Town of Hilton Head Island  
**Design Review Board Meeting**  
**Tuesday, September 14, 2021 – 1:15 p.m.**  
**AGENDA**

Town of Hilton Head Island  
**Design Review Board Meeting**  
August 24, 2021 at 1:15 p.m. Virtual Meeting  
**MEETING MINUTES**

Re: DRB 001598-2021 Wei Food Hall

On Aug 24<sup>th</sup> the DRB tabled the review of the Airport Terminal application in order to review additional information including changes to the roof slope to comply with LMO building height requirements. The letter requesting the additional information is included. The packet includes the revised drawings. To date, Staff has not received revisions to the color board but they are anticipated and will be available for review at Town Hall. If you have any questions do not hesitate to contact me.

**A-2**

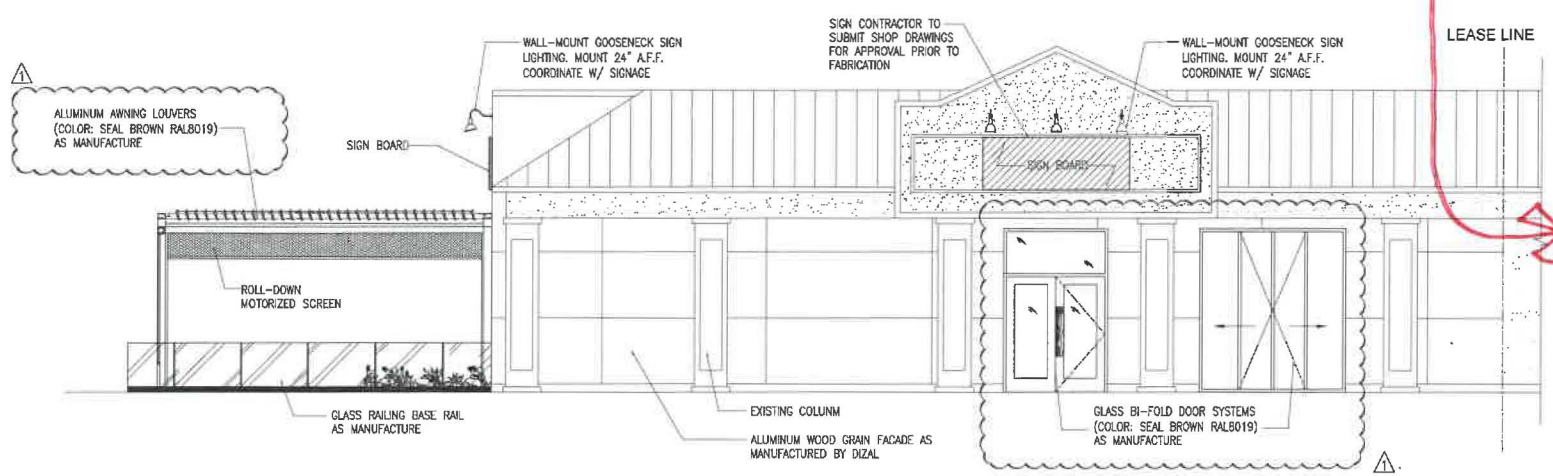
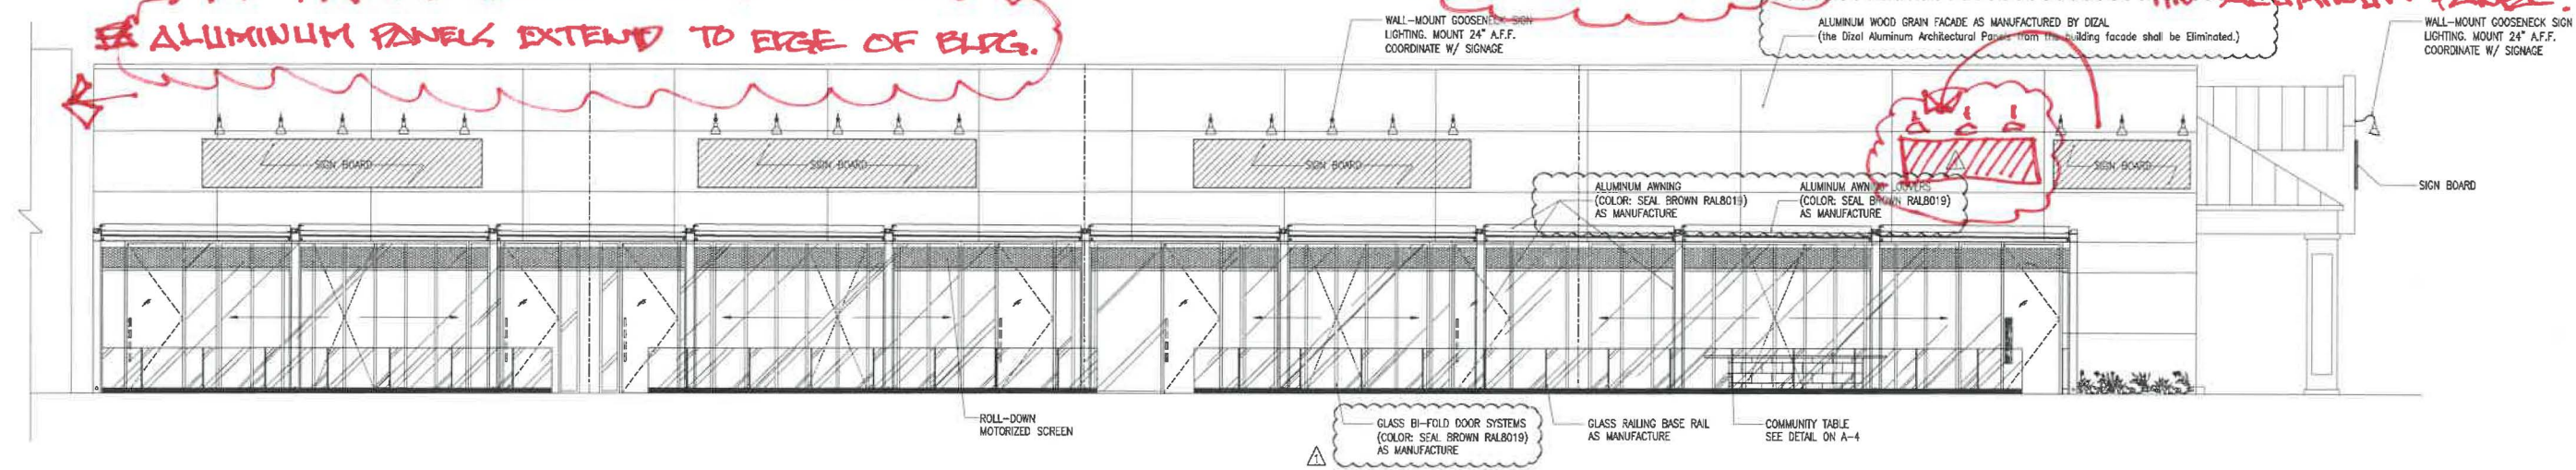
1. The drawings or narrative shall be revised to indicate the proposed aluminum architectural panels will extent to the Planet Fitness bump out and to the end of the building (left side in Store Front Elevation 2/A-2),
2. The drawings or narrative shall be revised to indicate the grain of the proposed aluminum architectural panels will be vertical,
3. The aluminum architectural panel sample (submitted to Staff as additional information) shall be made available for review by the DRB,
4. The drawings or narrative shall be revised to indicate the proposed sign and goose neck fixtures will be relocated over the awning system,

**ALUMINUM PANELS WILL EXTEND TO PLANET FITNESS BUMP OUT.**

**NOTE: WOOD GRAIN ON ALUMINUM PANEL WILL BE VERTICAL.**

**SHIFT SIGNAGE & GOOSE NECK FIXTURES OVER AWNING CENTERED IN ALUMINUM PANEL.**

**ALUMINUM PANELS EXTEND TO EDGE OF BLDG.**

SHEET NUMBER  
**A-012**

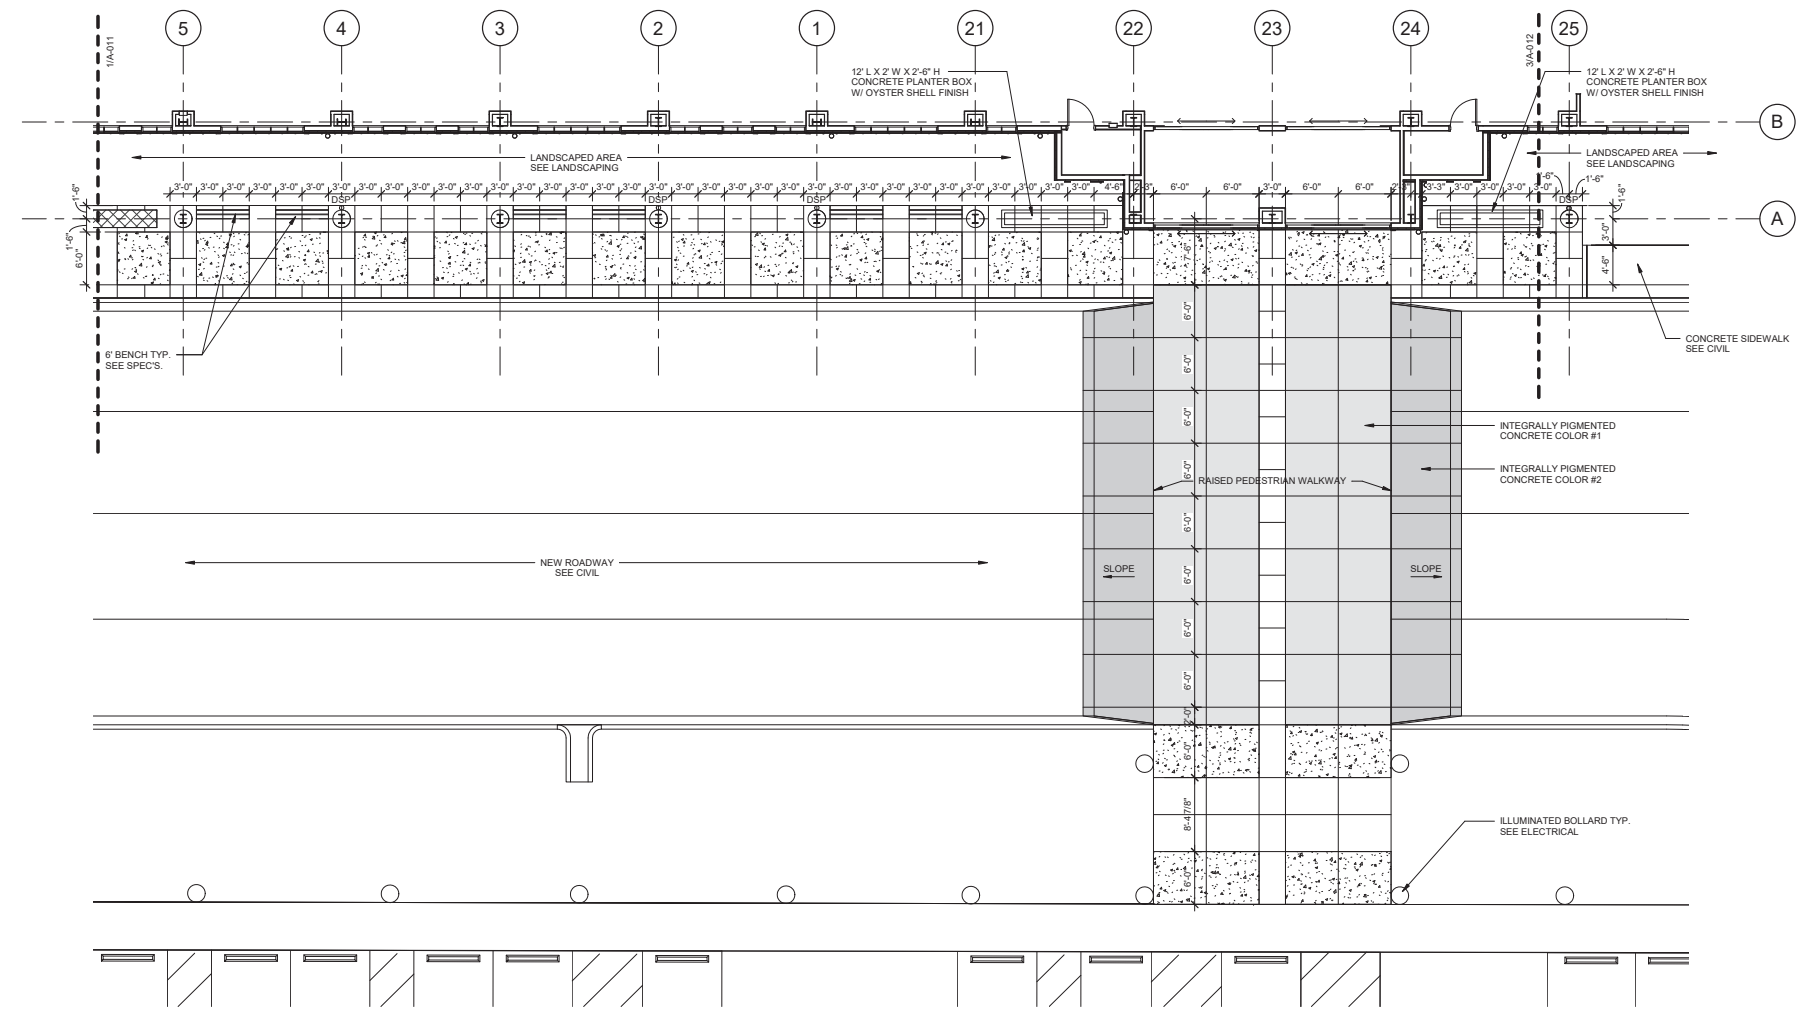
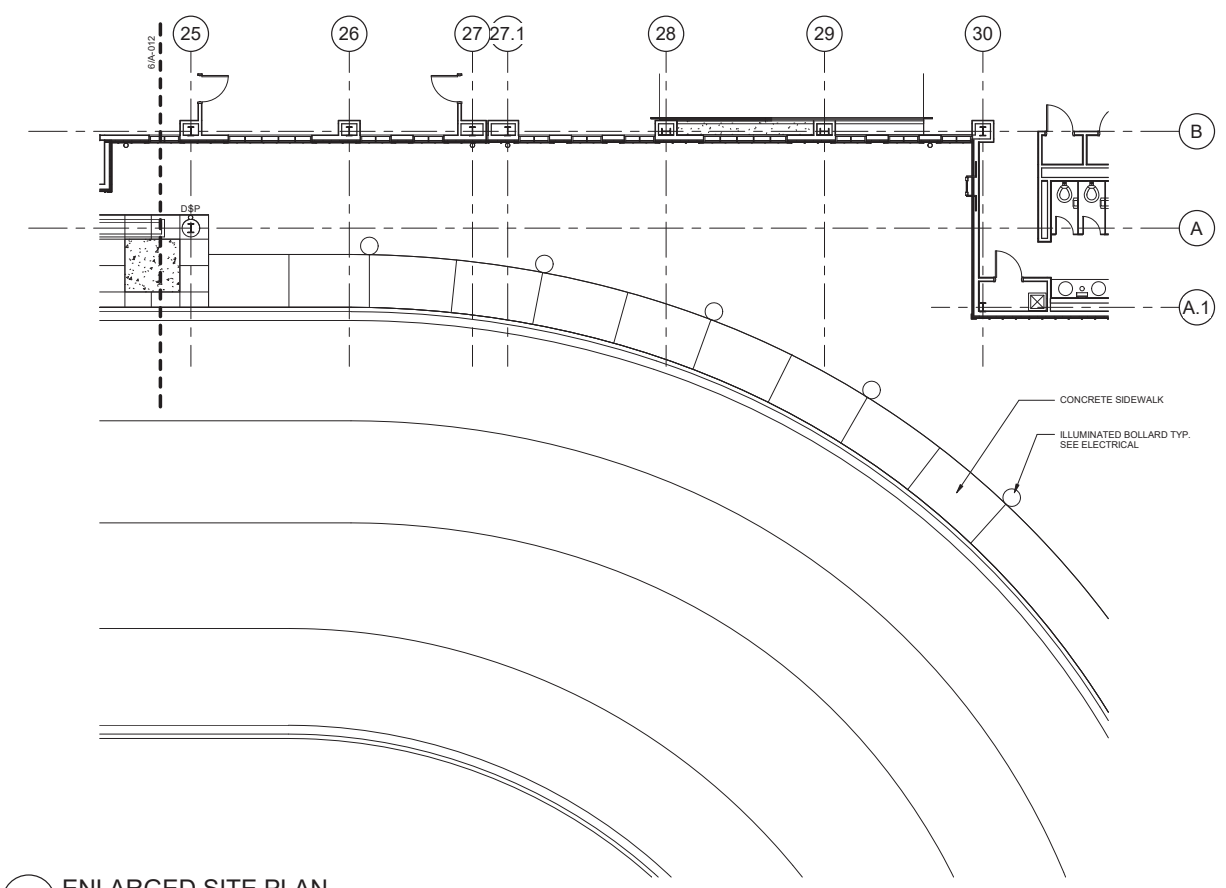
**Comment:** Articulate the ground plane at pavement markings & crosswalks.

**Response:** A combination of materials and colors has been incorporated into the passenger drop-off/pick up sidewalk and at the cross-walks to the parking lot. These include the use of oyster shell concrete finish. This is reflected on the architectural site plan and site details sheets.

SHEET NUMBER  
**A-221**

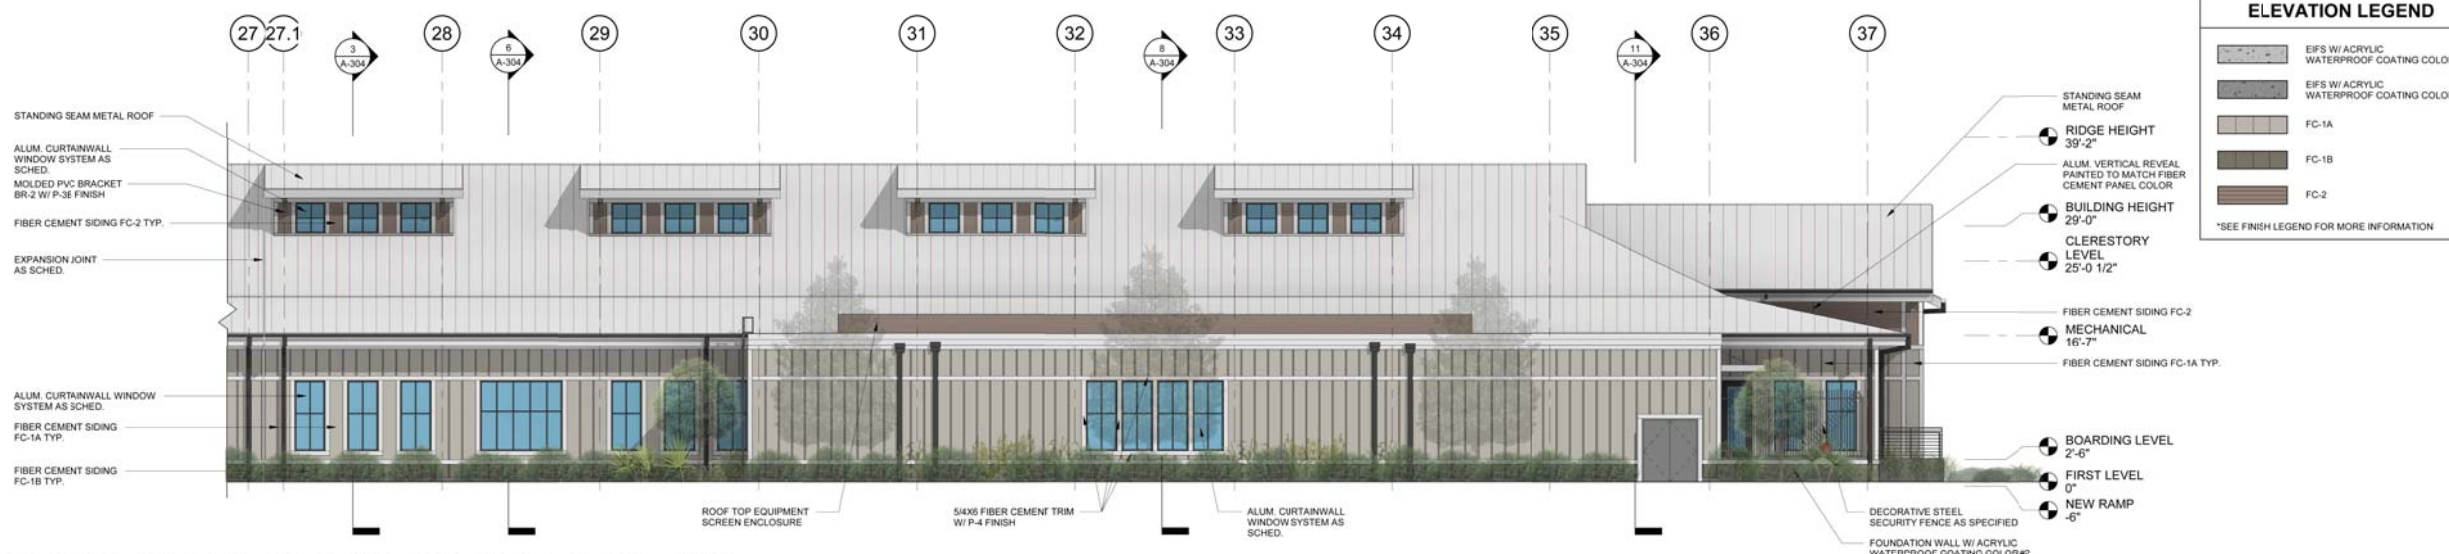
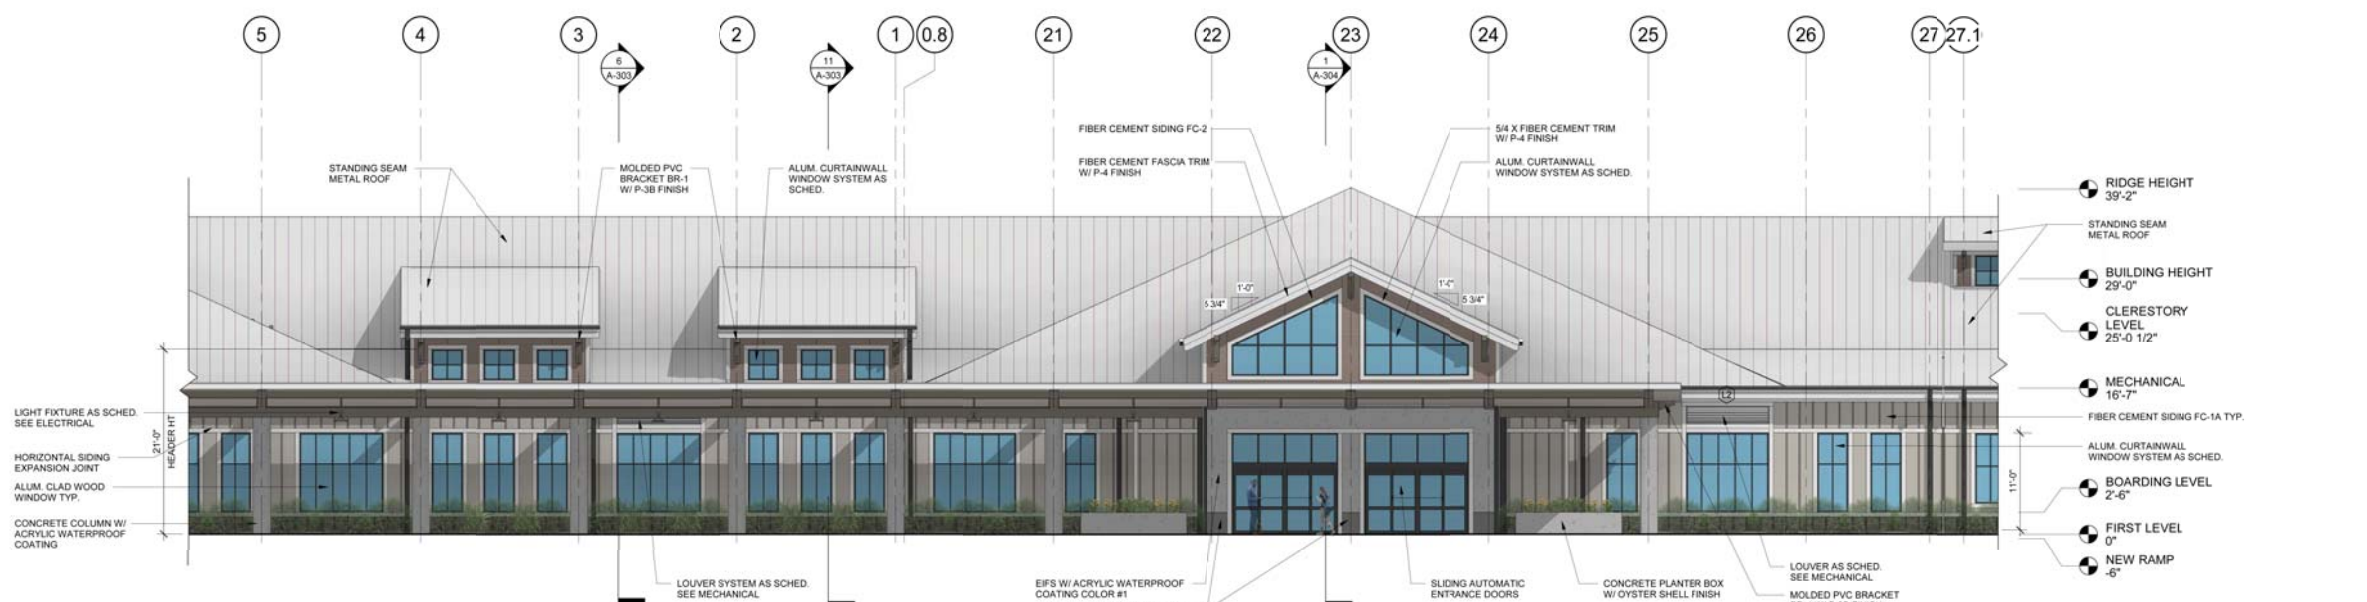
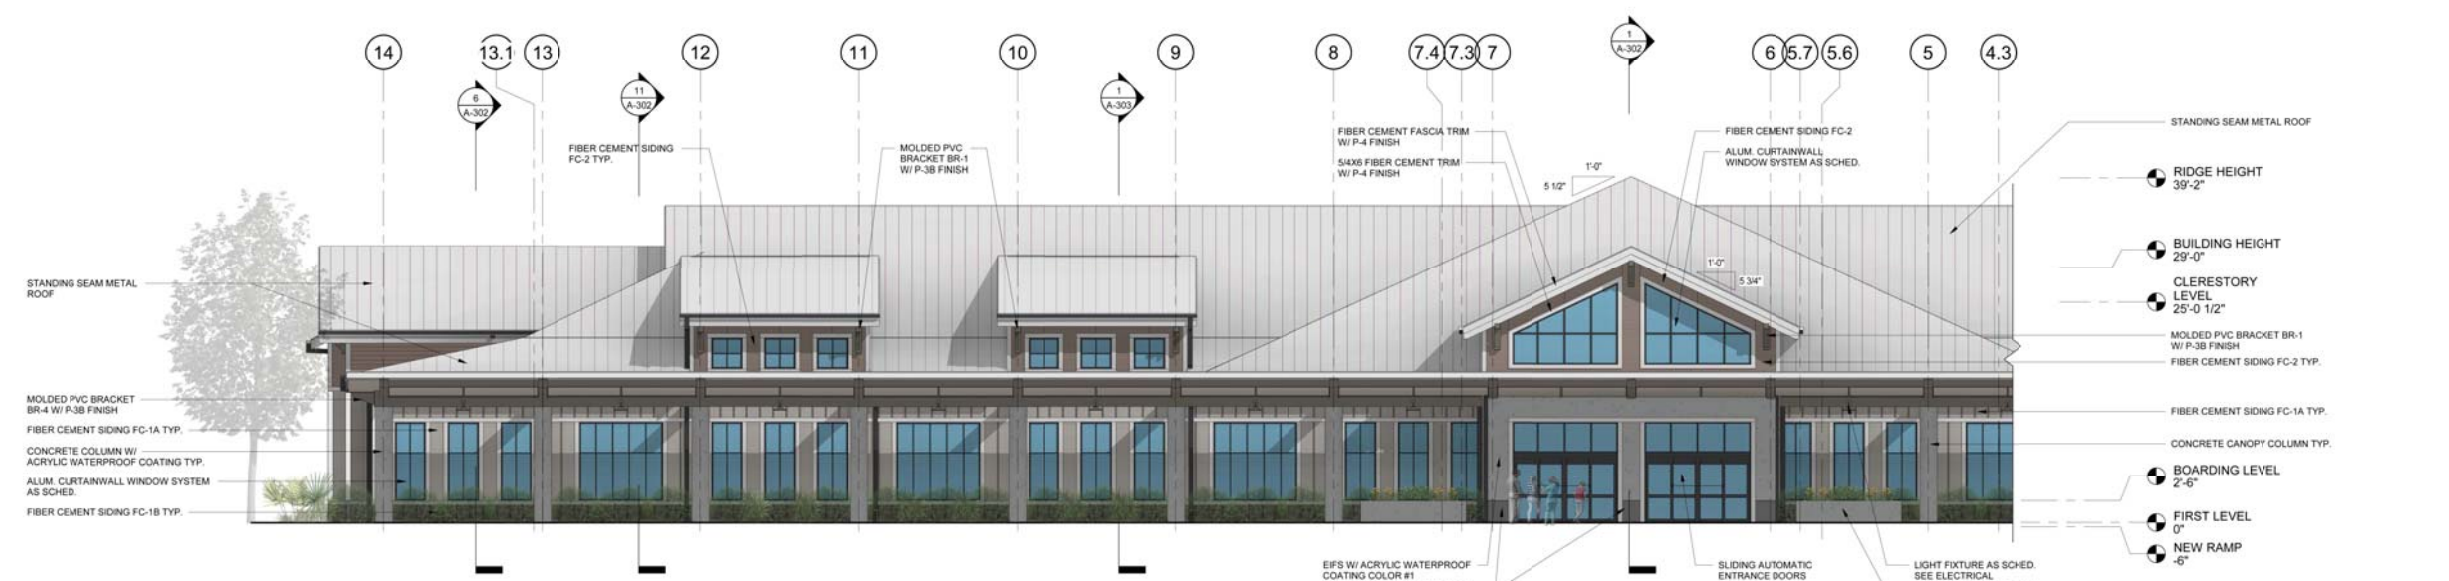
**Comment:** Provide a detail of the proposed vertical siding illustrating a ¾" minimum deep reveal or a board & batten system.

**Comment:** Specify large tabby planters at building entrances and exits.

**Comment:** Revise the roof pitch in the elevations and/or illustrations to accommodate the building height restrictions.

**Comment:** Reduce the number of downspouts and specify a round, bronze colored downspout.

**Response:** Architect proposed a board & batten system comprised of painted fiber cement. This has been reflected on the elevation drawings and perspectives. Attached is a sketch of the proposed system detail.

**Response:** Large tabby planters are shown on the plans, elevations and perspectives at the entrances.

**Response:** The elevations and perspectives have been modified to reflect the roof pitch change so that the proposed building height matches the existing building height.

**Response:** The number of downspouts at the canopy have been reduced by half. The downspouts have been changed to round and bronze colored. These modifications are shown on the plans, elevations and perspectives.
